CITY OF DURHAM + DURHAM OUTDOOR AQUATICS STUDY

WHEELS FUN PARK RINK - CODE ANALYSIS

AUGUST 19, 2022

Wheels Recreation Center

ENTRY/EGRESS

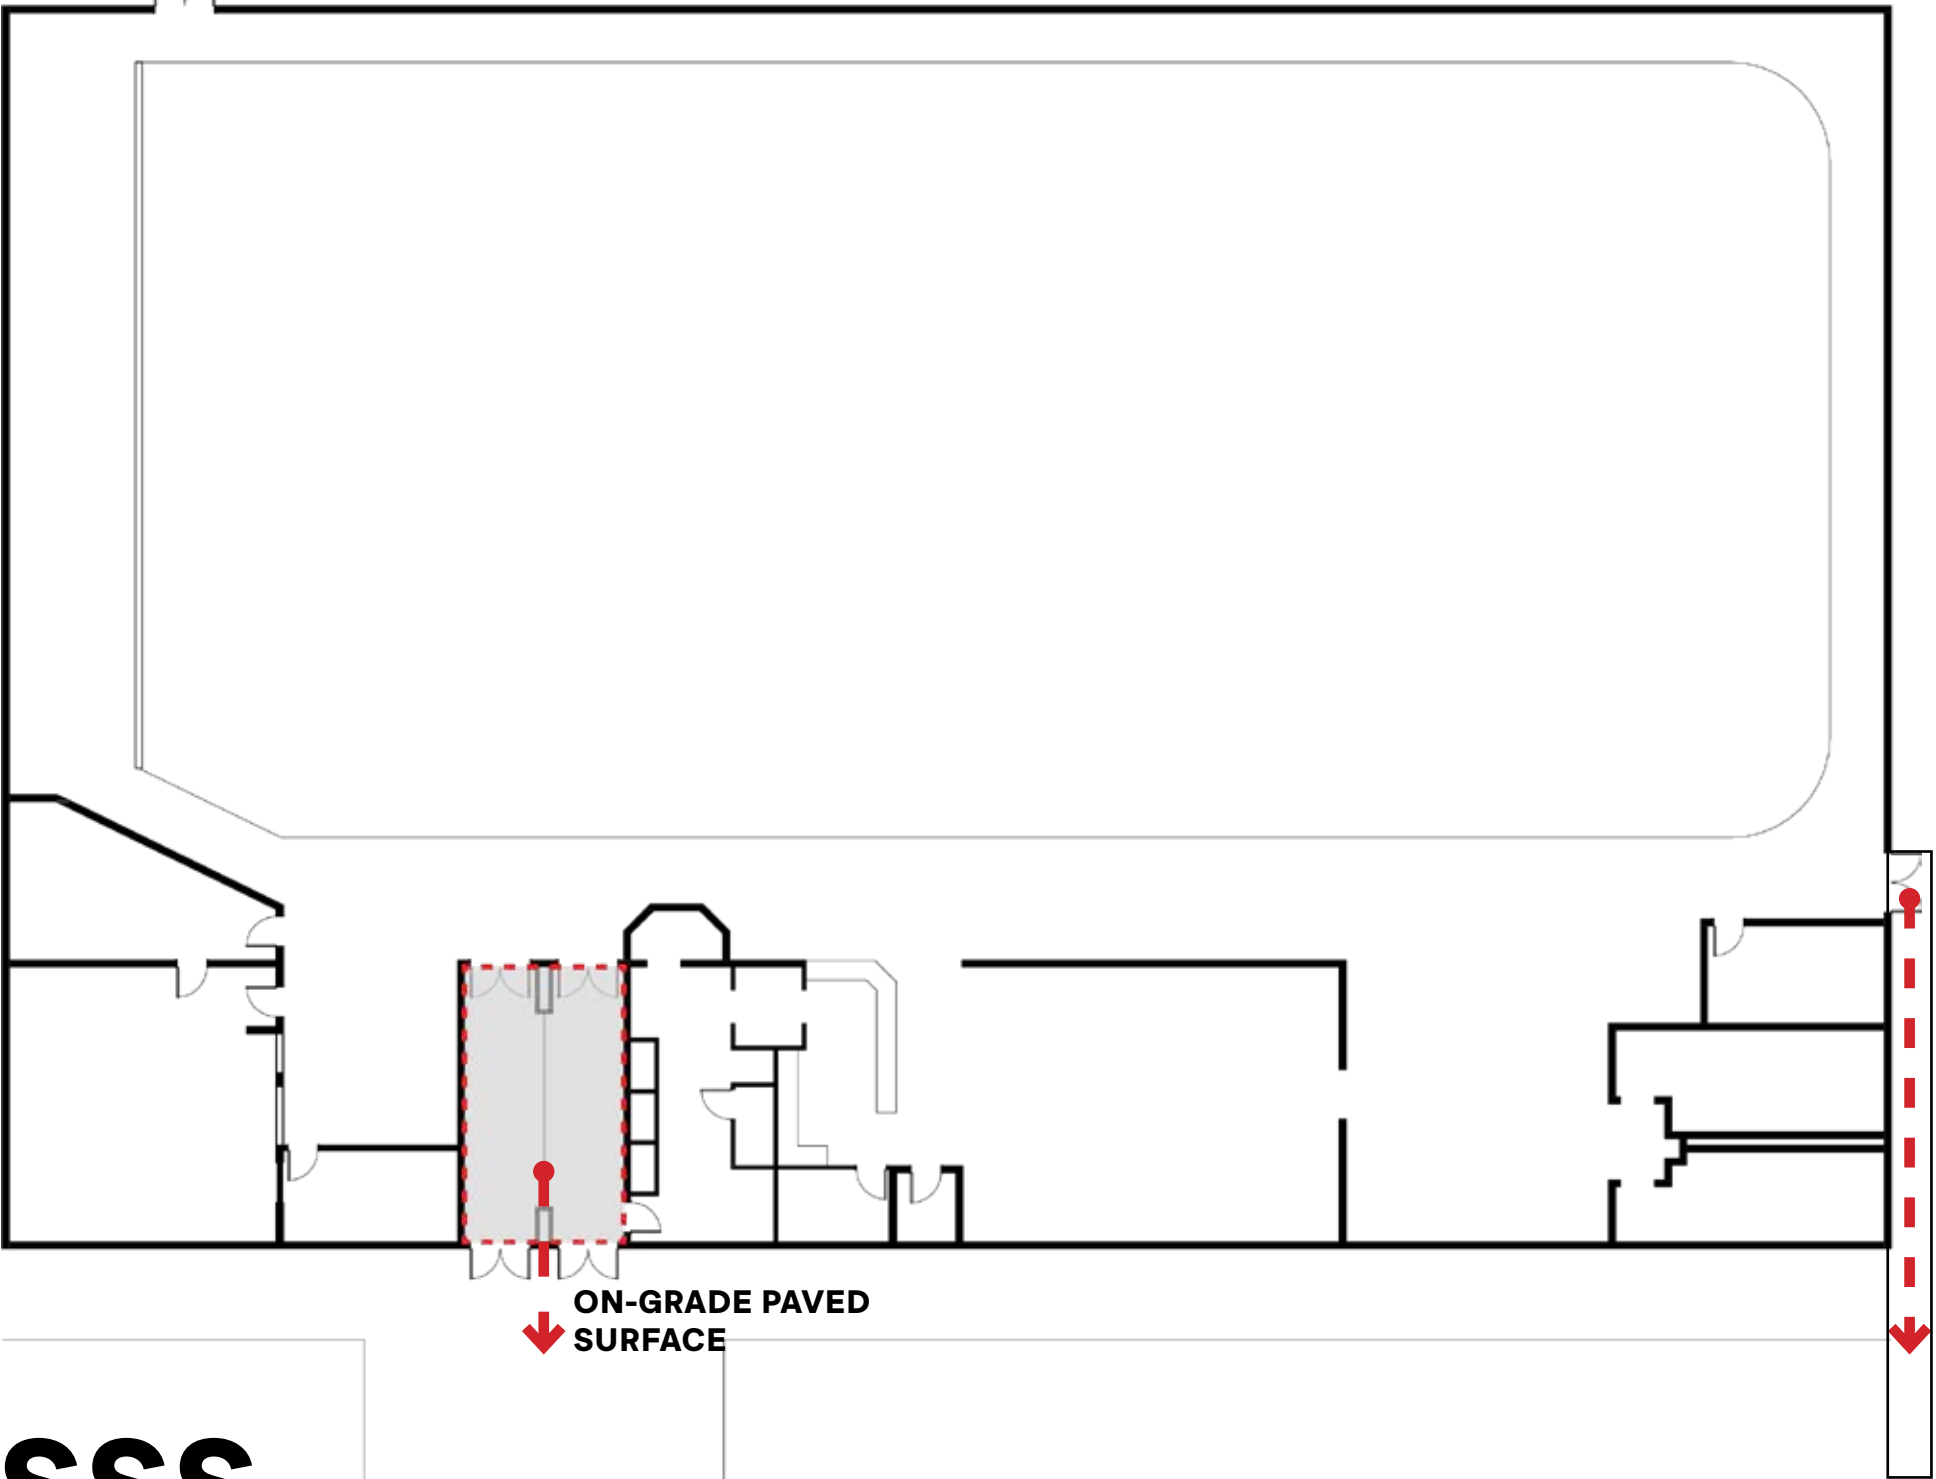
- The parking lot does not have curb ramps for accessibility. Parking area curb ramps will need to be constructed to provide accessible parking. [2017 ICC A117.1 - Section 406]
- Provide access aisle for van parking that can be shared between two accessible parking spaces. [2017 ICC A117.1 - Section 502]
- Optional: affix the entry and exit doors with automatic door opening hardware. [2017 ICC A117.1 - Section 404]

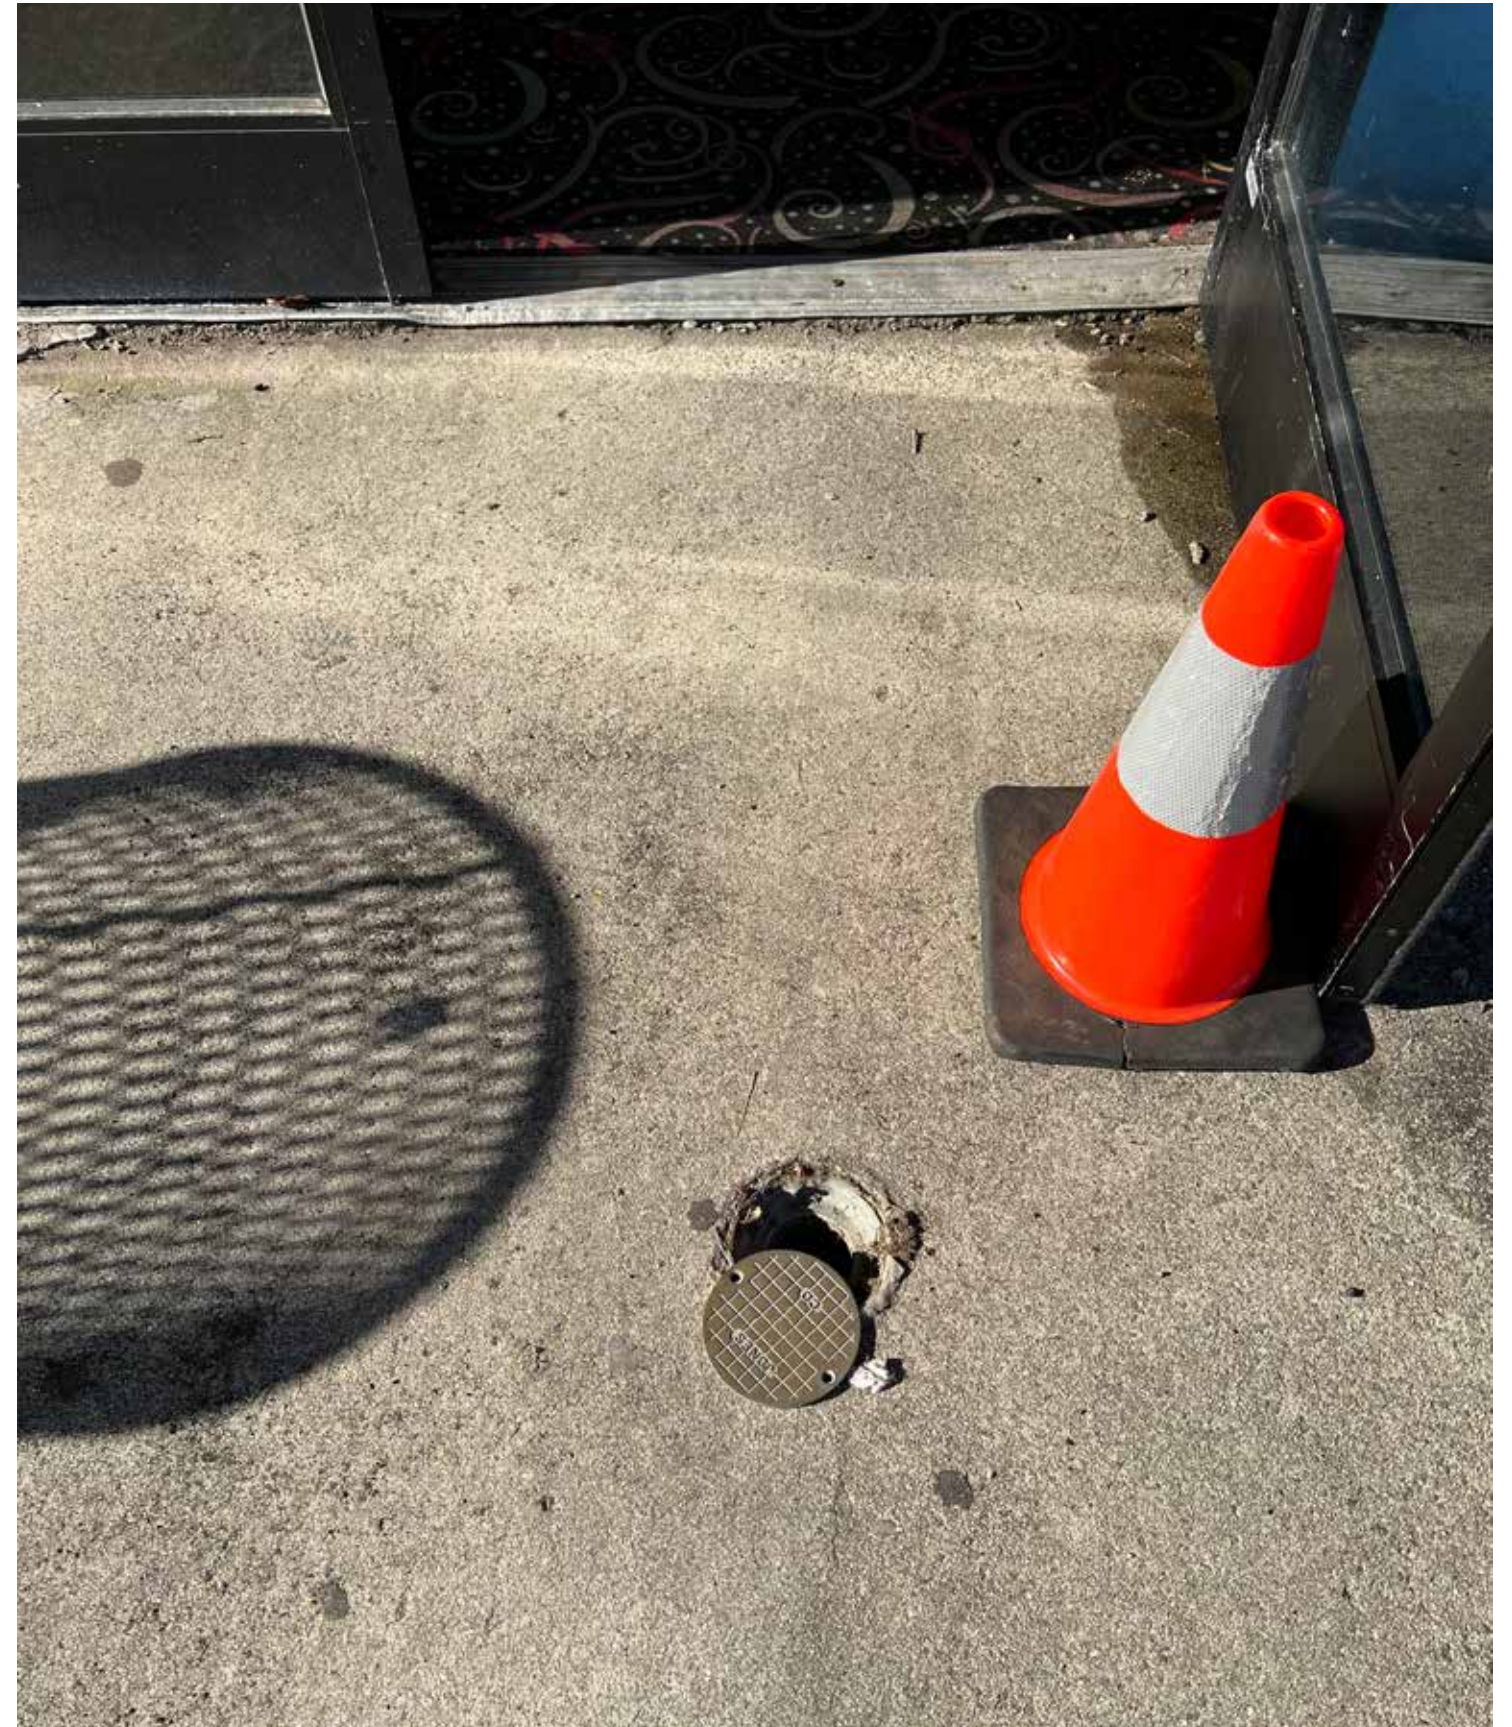
- Door entry + exit transitions exceed the required height of 1/2". Fill will need to be added to raise the transition from sidewalk to door entry. [2017 ICC A117.1 - Section 303]

- Ticket counter height is at 37" in height. The accessible requirement is at 36". This counter will need to be lowered. [2017 ICC A117.1 - Section 904]

- Drain trip hazard located in front of the entry door. Secure the drain cover.
- The rear egress door does not have an accessible route to an area of refuge. Clear path to provide accessibility. [2017 ICC A117.1 - Section 402]

EXTERIOR
ADA RAMP

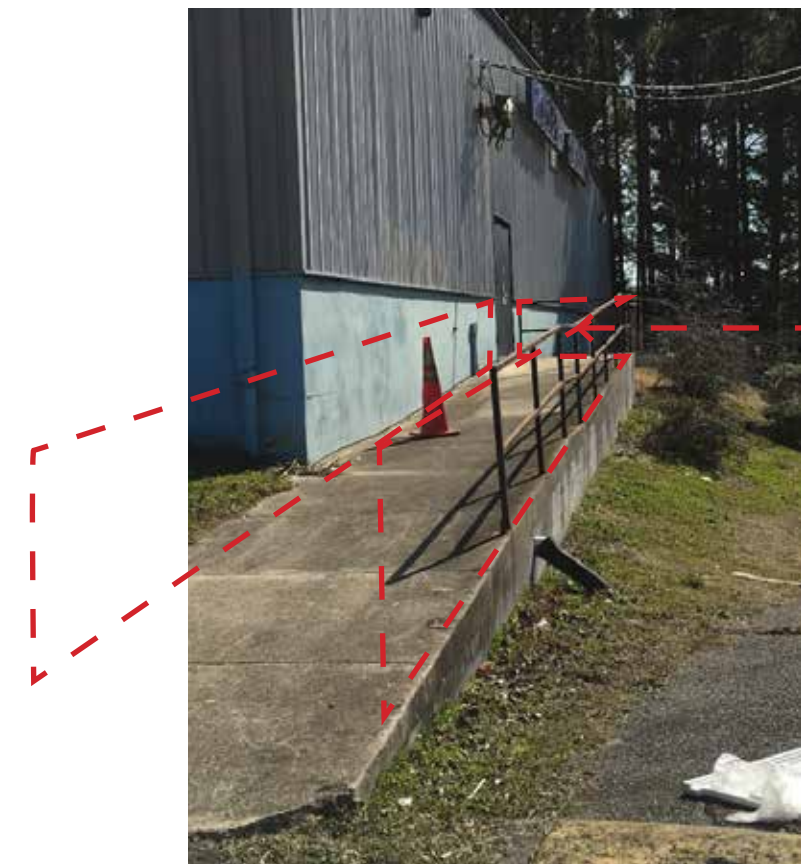
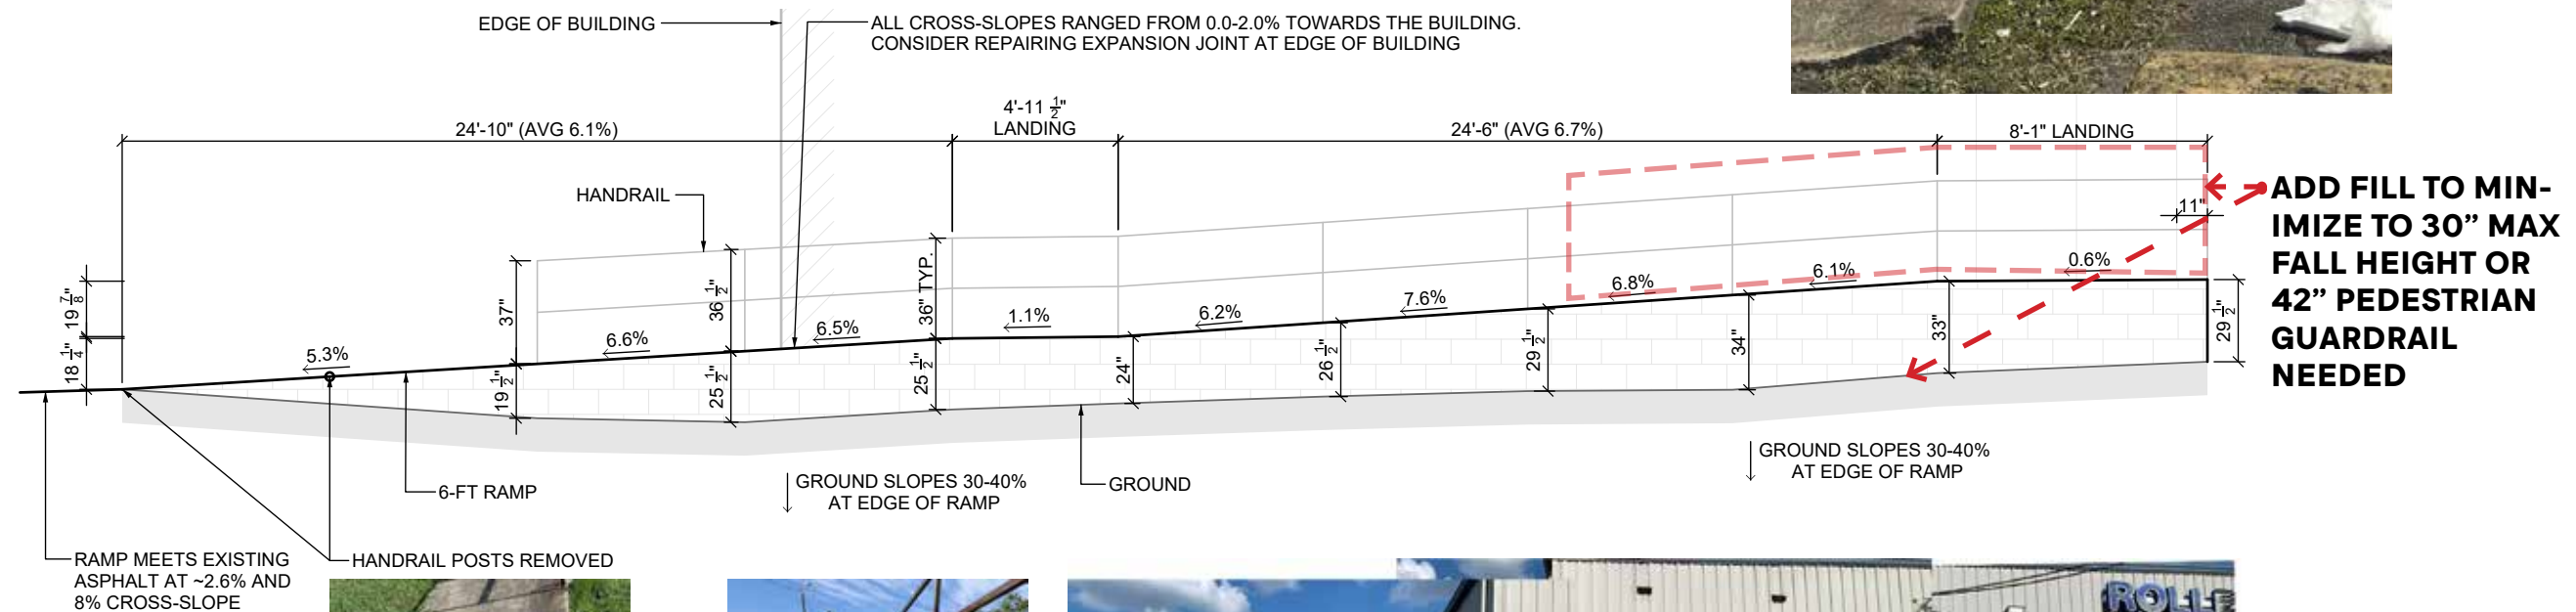
- Surface slopes along existing ramp are acceptable but bottom of ramp does not meet an ADA compliant route. Ramp would need to be reconfigured to turn around northwest corner of building to meet an accessible grade.
- Existing single handrail does not meet current ADA requirements. Handrail to be removed & replaced with ADA compliant handrails on both sides of ramp.
- One area along the ramp has >30" fall height. Fill would need to be added to decrease fall height or new pedestrian guardrail would need to be added for the top landing

NEW COMPLIANT
HANDRAIL NEEDED ON
BOTH SIDES OF RUNS
>5% SLOPE

OFFICE

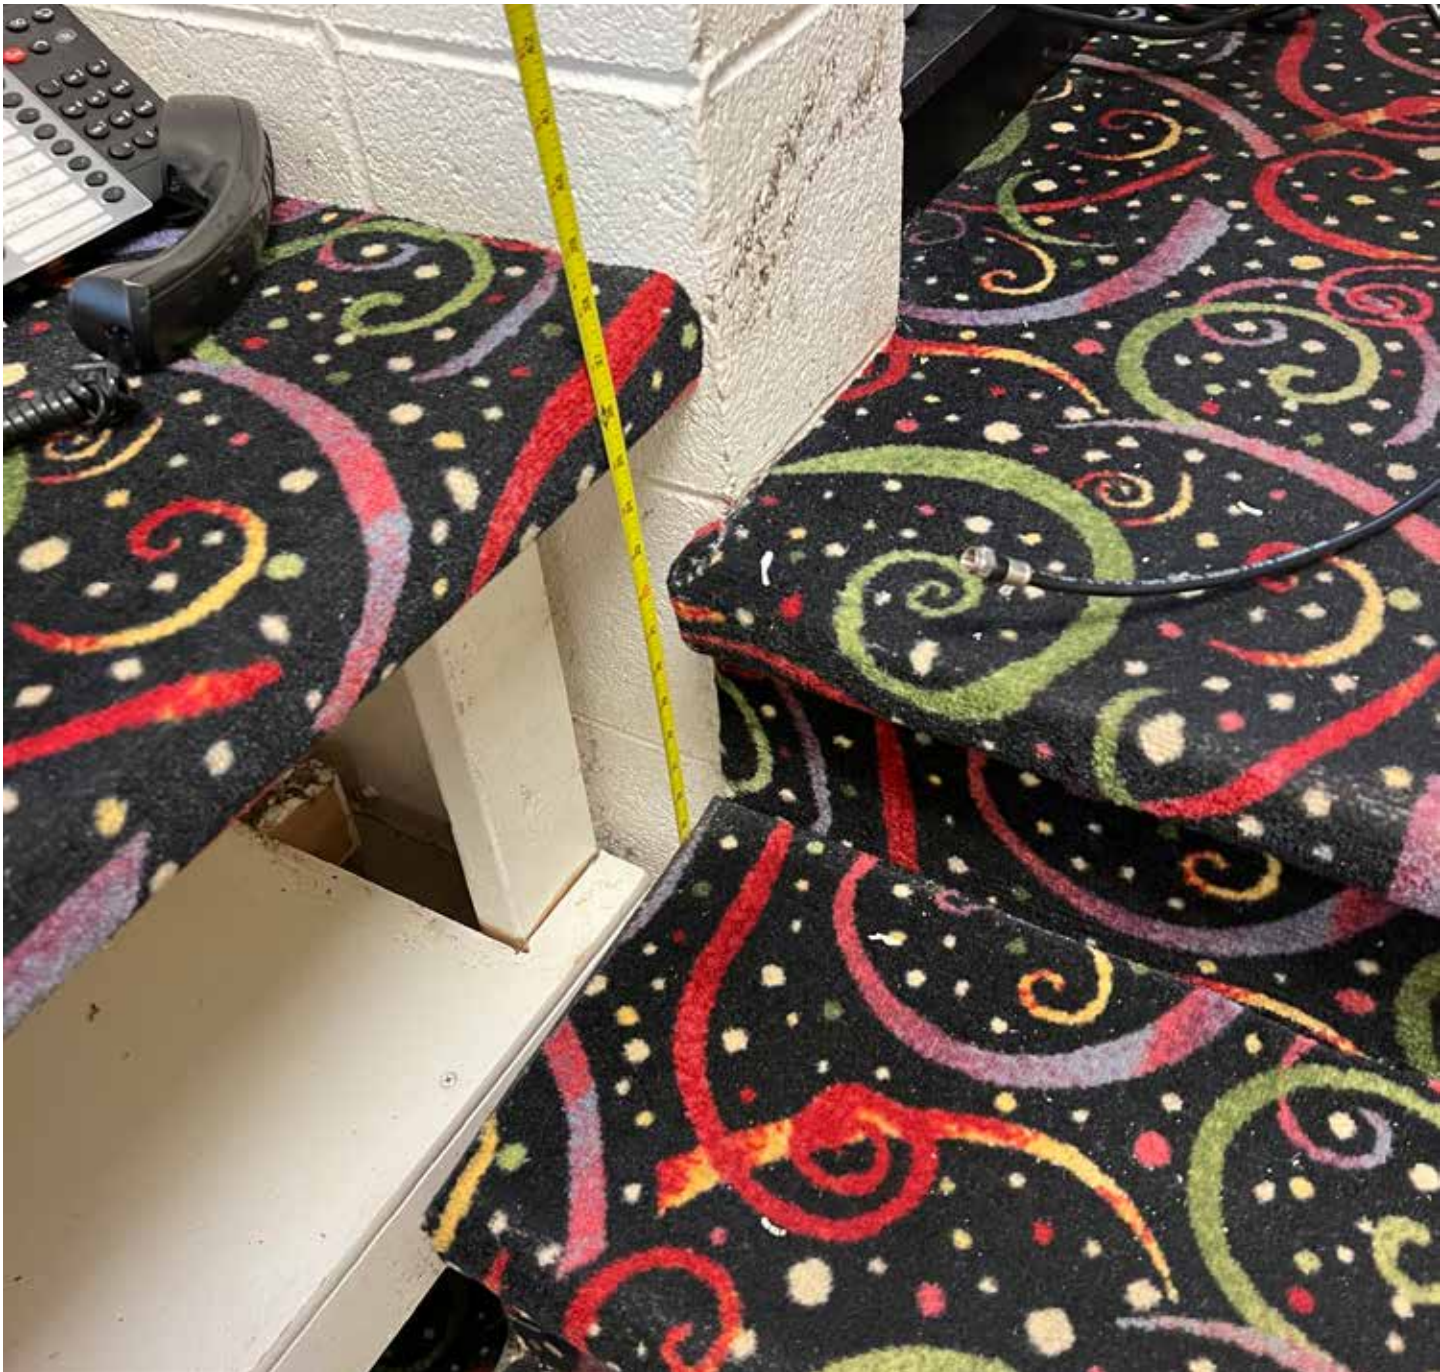
- The “pull” clearance on the office door does not meet the 18” clear dimension. The adjacent trophy display wall will need to be shifted by 10”. [2017 ICC A117.1 - Section 404]
- Door hardware on each of the three office doors will need to be replaced from knobs to levers. [2017 ICC A117.1 - Section 309]

- Investigate when the most recent fire inspection was completed and if the building has met those requirements.

- The DJ booth area is not accessible. The platform does not have an accessible route and does not have the proper floor clearance for turning space. It would be recommended to enlarge this area, relocate, or alter to provide accessibility. [2017 ICC A117.1 - Section 304, 406]
